HISTORIC AND DESIGN REVIEW COMMISSION

March 3, 2021

HDRC CASE NO: 2020-195
ADDRESS: ROW near 1430 E HOUSTON ST
LEGAL DESCRIPTION: NCB 575 BLK 14 LOT 19
ZONING: I-1, H
CITY COUNCIL DIST.: 2
DISTRICT: Dignowity Hill Historic District
APPLICANT: Steve Salinas/Modus LLC
OWNER: City of San Antonio
TYPE OF WORK: Installation of a new network wood pole
APPLICATION RECEIVED: December 3, 2020
60-DAY REVIEW: Not applicable due to City Council Emergency Orders
CASE MANAGER: Huy Pham

VERIZON SITE ID:
SADT_CHERRY_CROCKETT_SC

Pole on property pole

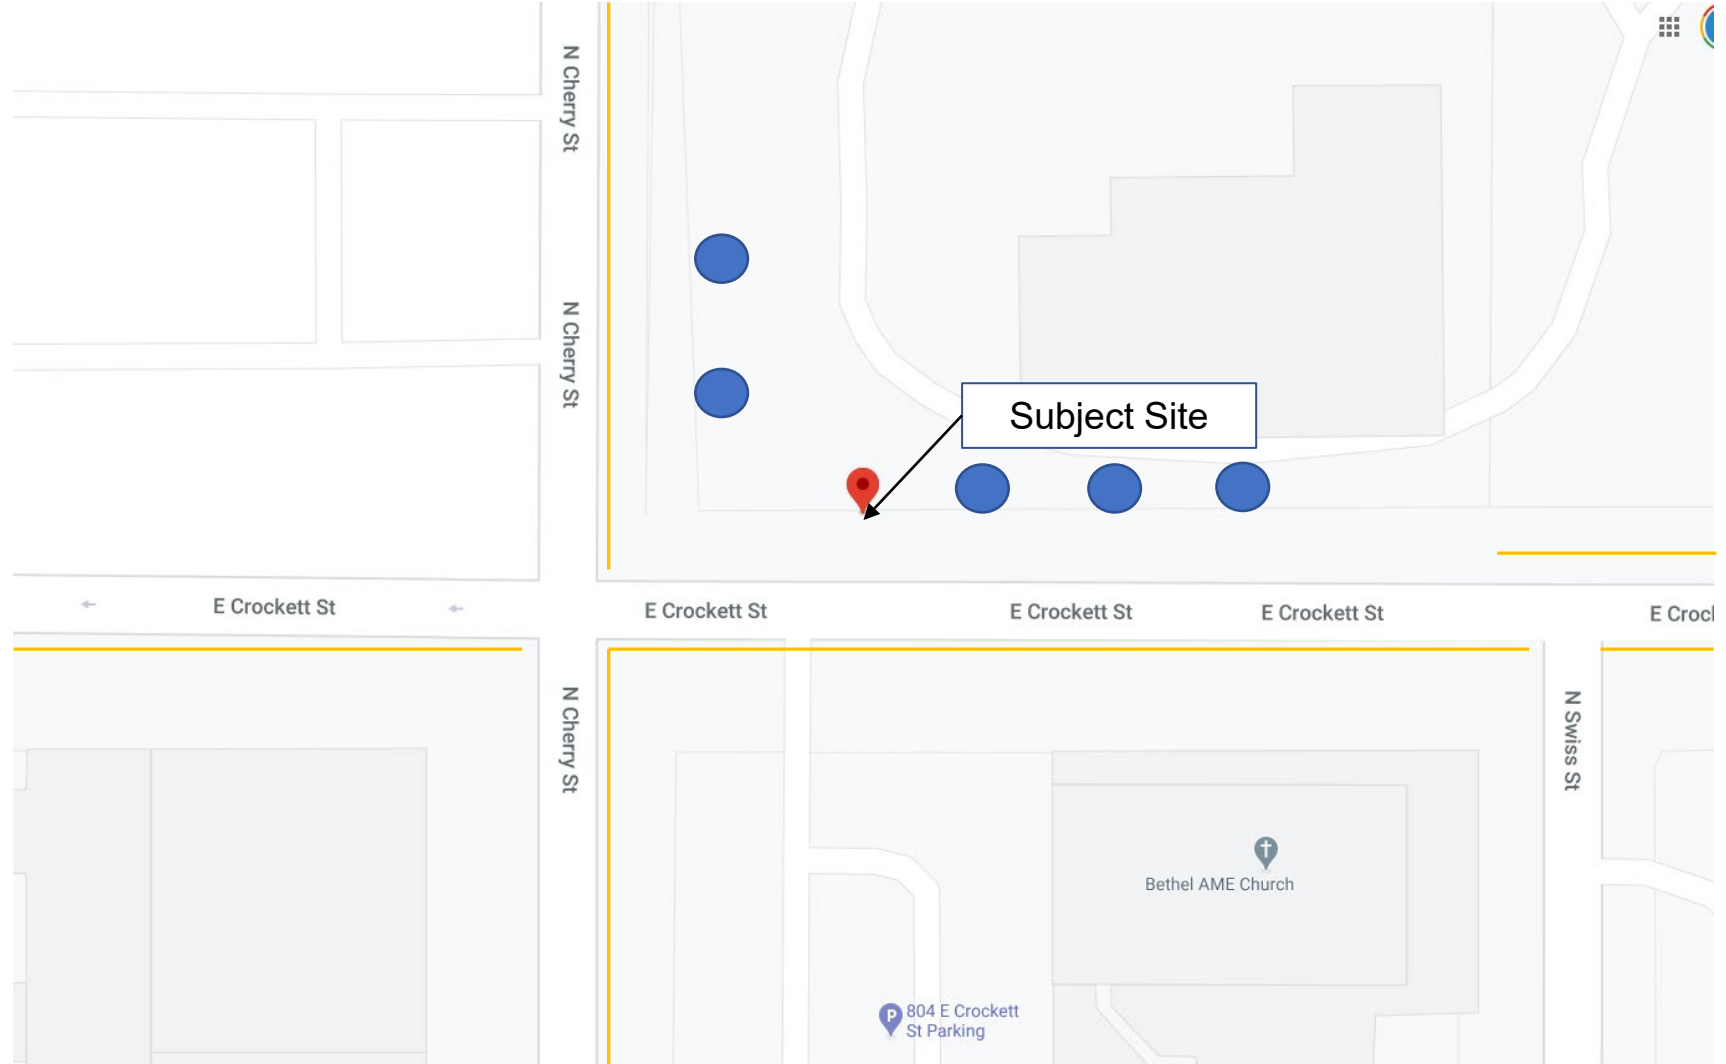
Existing CPS wood utility poles – not viable due to the pole having transmission lines, transformers, air switches or other CPS equipment on them that CPS does not allow (see next page)

No existing viable vertical assets. All nearby CPS poles are not viable colocation candidates since they are either transformer poles or have risers on them which CPS doesn't allow

- COLLOCATION - Documented efforts to explore a nearby collocation have not been submitted.
 - RESPONSE: See previous two slides. There are no viable existing collocatable poles in the immediate area where Verizon's radio frequency engineer has noted a need for coverage/data capacity improvements
